ADDENDUM NO. 2

**LUMS POND STATE PARK
UTILITY IMPROVEMENTS, PHASE II
CONTRACT No. 2015-LP-100**

September 18, 2015

Project Name: Lums Pond State Park
Utility Improvements, Phase II

DRIVEWAY – PERMEABLE
NOT TO SCALE

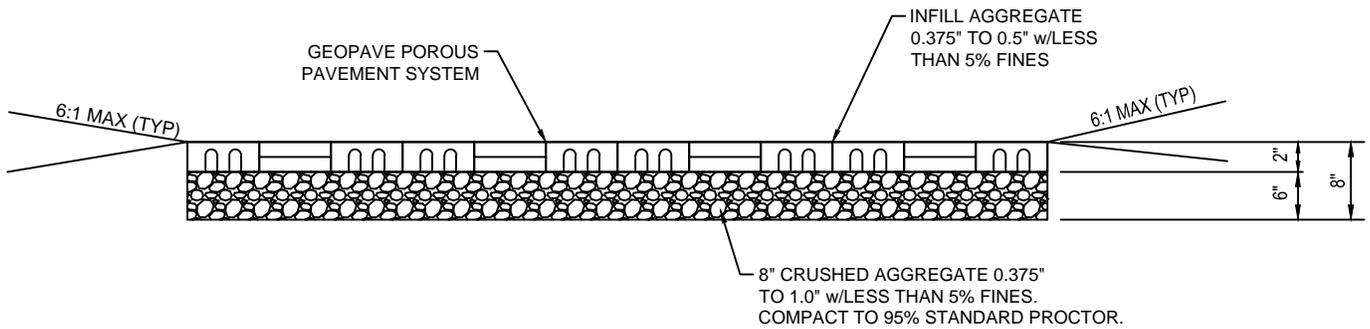
9. Building Utility Stub Up drawings have been included as Attachment 2.
10. In order to satisfy DNREC stormwater concerns, DNREC may elect to install a porous paving system in accordance with Attachment 4 on a driveway(s).

E&S NOTES AND DETAILS 2, PROJECT INFORMATION (DATE: 05/14/15, REVISION: D, PROJECT NO: 20712904, SHEET NO: ES-06), SHEET SEQUENCE: 06 OF 10.

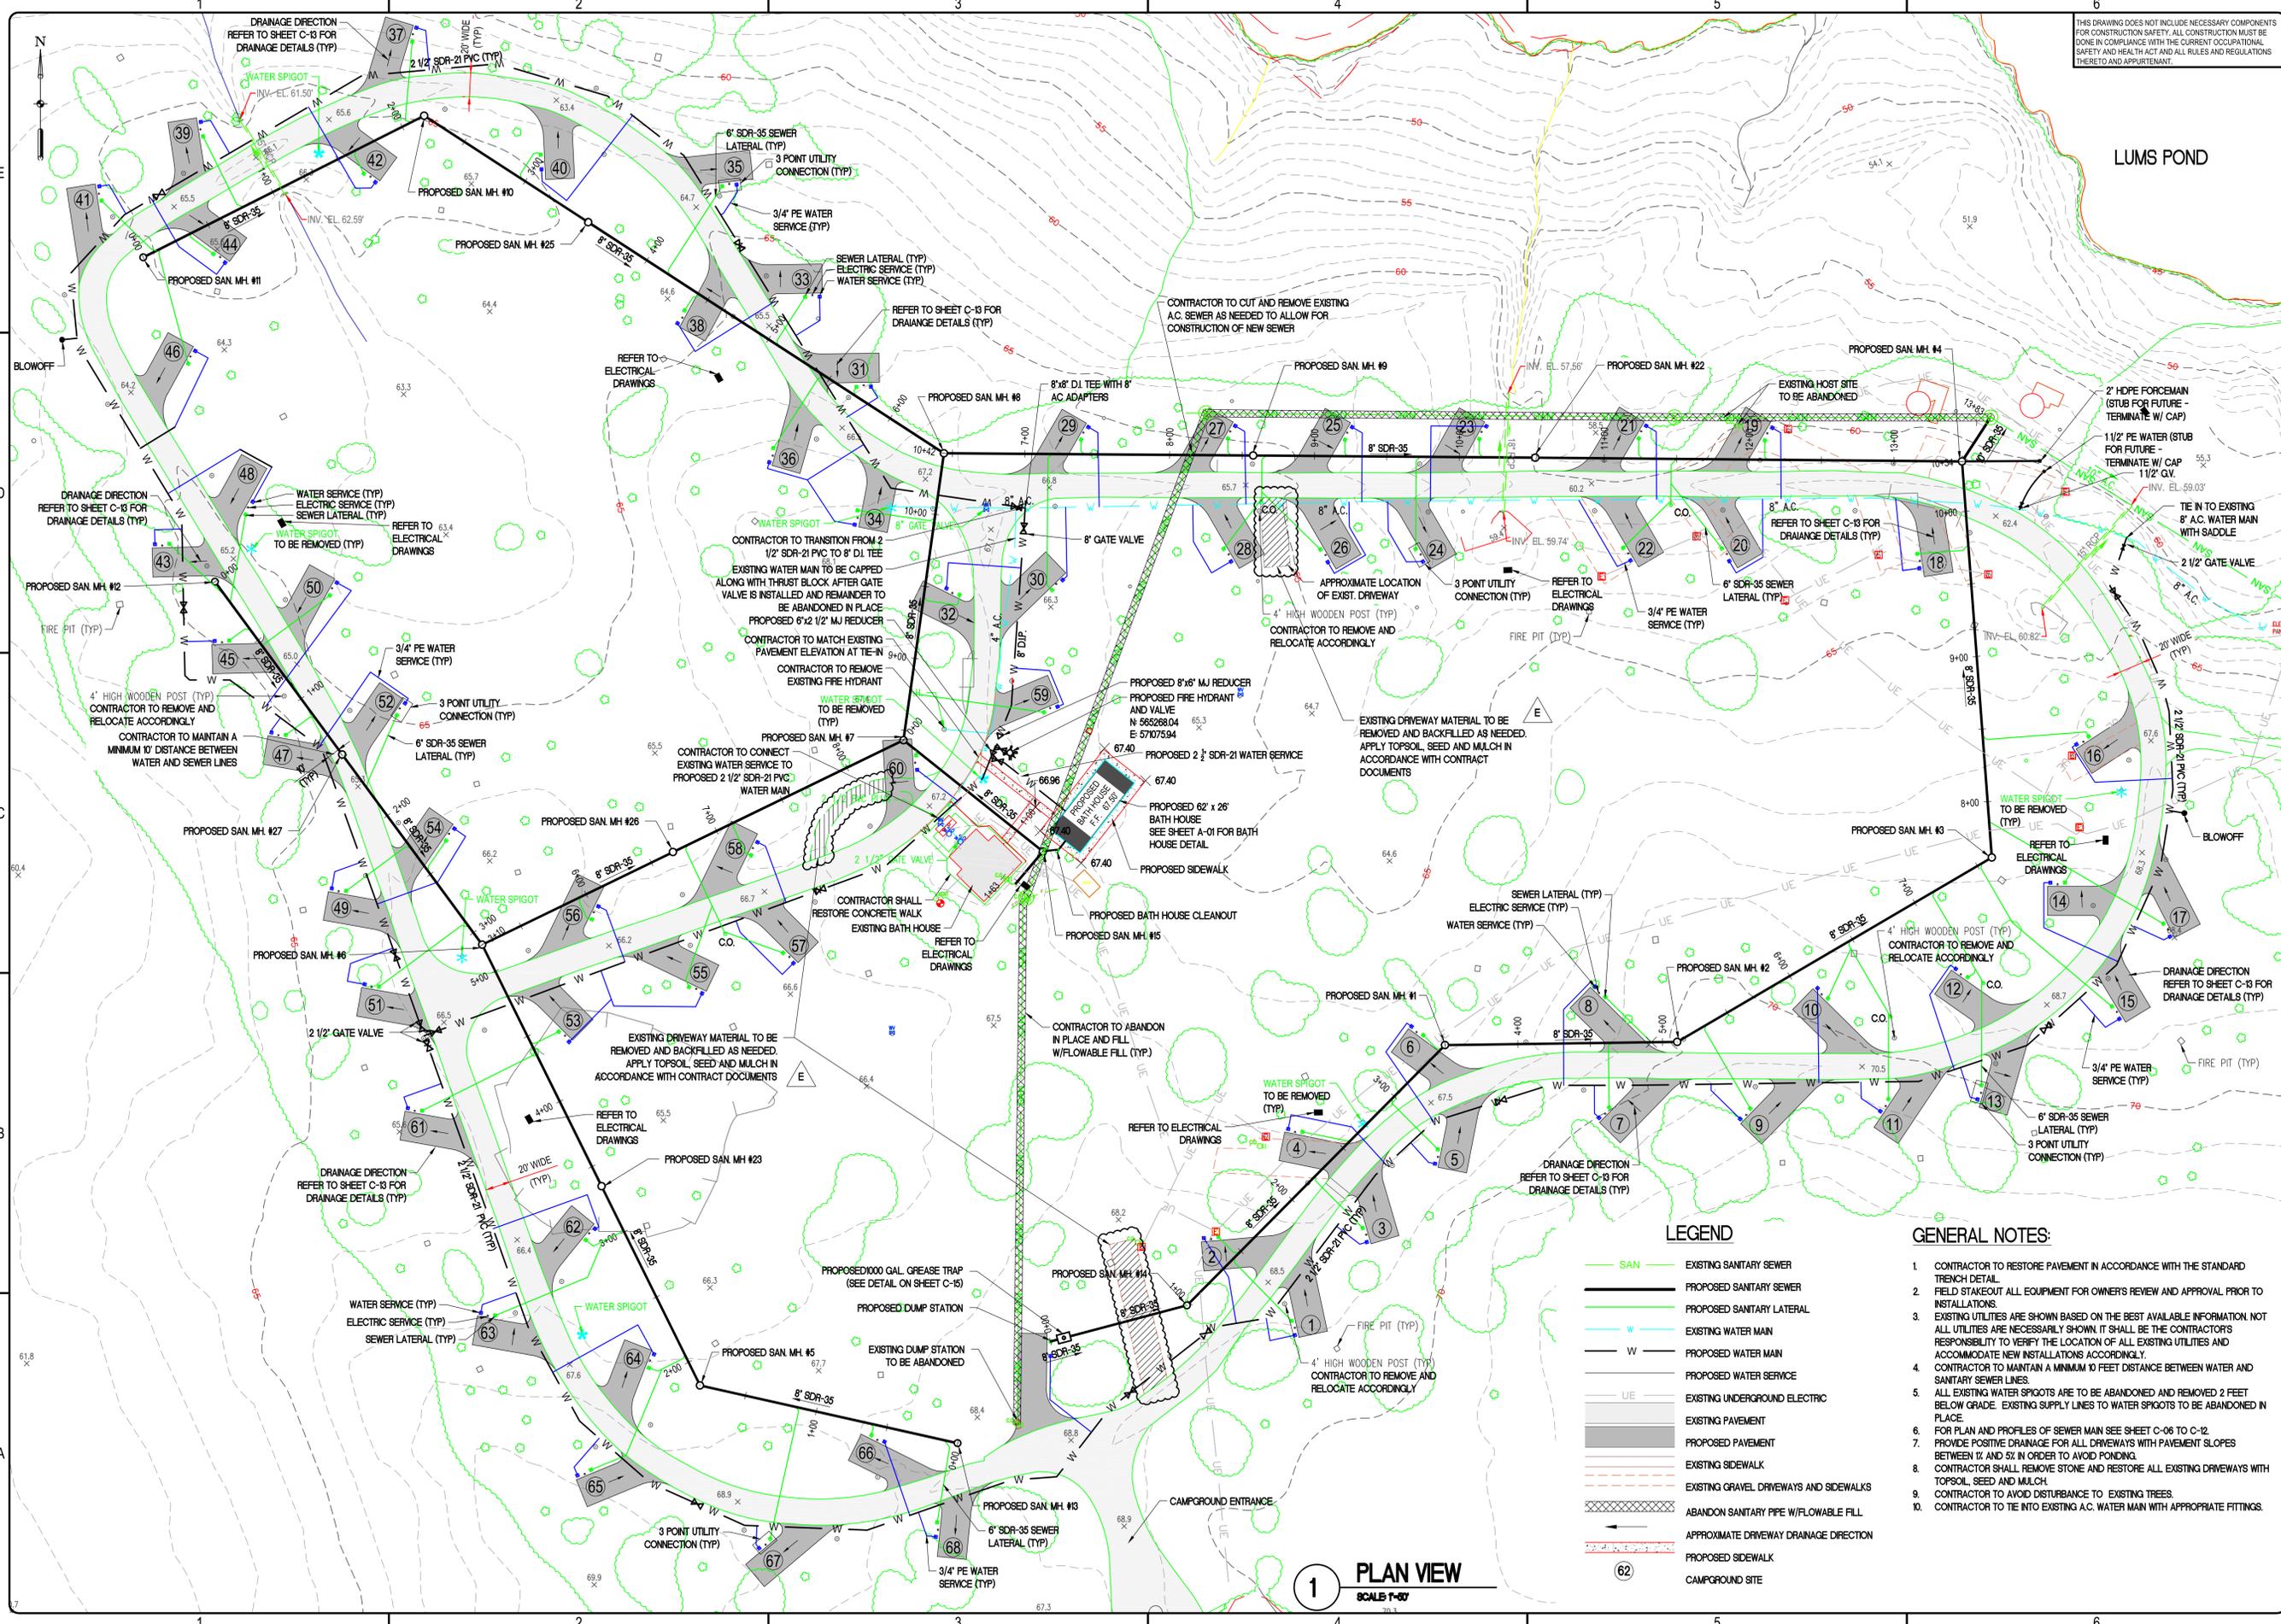
11. Title Sheet – Sediment and Stormwater Management Plans – Delete note 6.c. These plans are for construction.
12. Delete Drawing ES-06 and replace with the attached ES-06. Detail ESC-3.6.1 was added to the sheet.
13. G-02 – Note 27 – Contractor to provide a 4 feet by 8 feet metal sign stating “CAMPGROUND CLOSED UNTIL MEMORIAL DAY 2016” and sign shall be in accordance with MUTCD. Contractor to submit the sign to DNREC for approval prior to fabrication.
14. Delete Sheet C-04 and replace with attached Sheet C-04.
15. Delete Sheet C-05 and replace with attached Sheet C-05.
16. Sheet C-07 – Delete note indicating water crossing at approximate station 10+25.

TYPICAL DRIVEWAY DETAIL
NOT TO SCALE

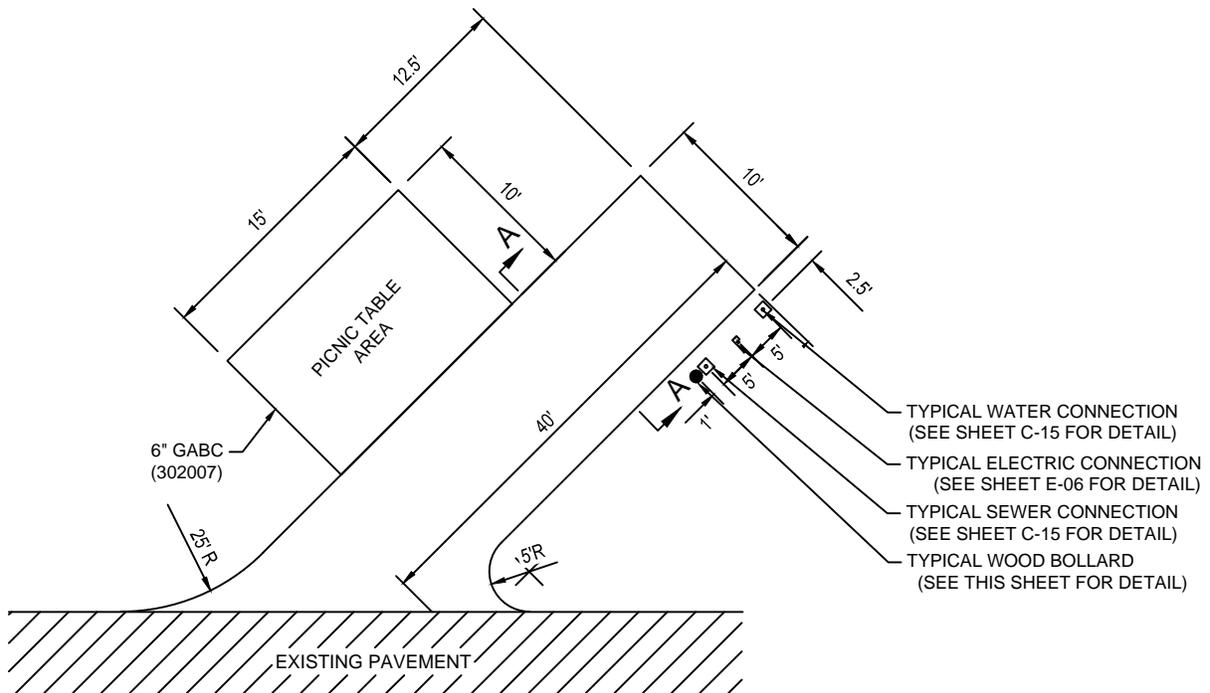
19. Sheet C-13 – Delete Typical Driveway Detail and replace with the Typical Driveway Detail included as Attachment 3.

48" Ø MANHOLE DETAIL
SCALE: NONE

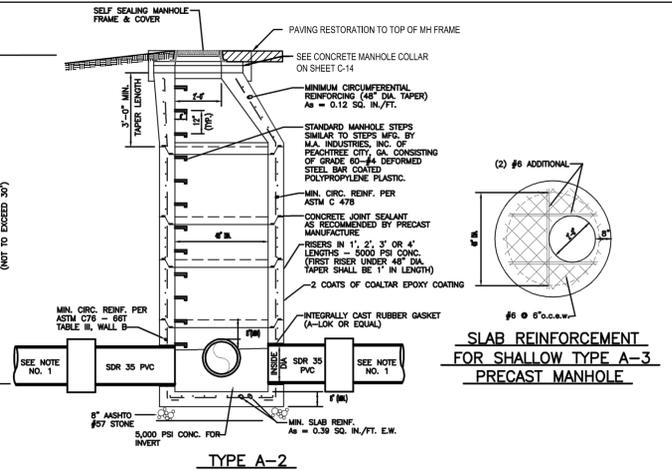
22. Sheet C-16 – 48” Diameter Manhole Detail – Delete the note pointing to the manhole frame and cover indicating “See Concrete Manhole Collar on Sheet C-14” and replace it with “See Sanitary Sewer Manhole Frame and Cover Replacement Detail” for instructions on how all frames are to be adhered to precast riser sections and subsequent construction of concrete collar.
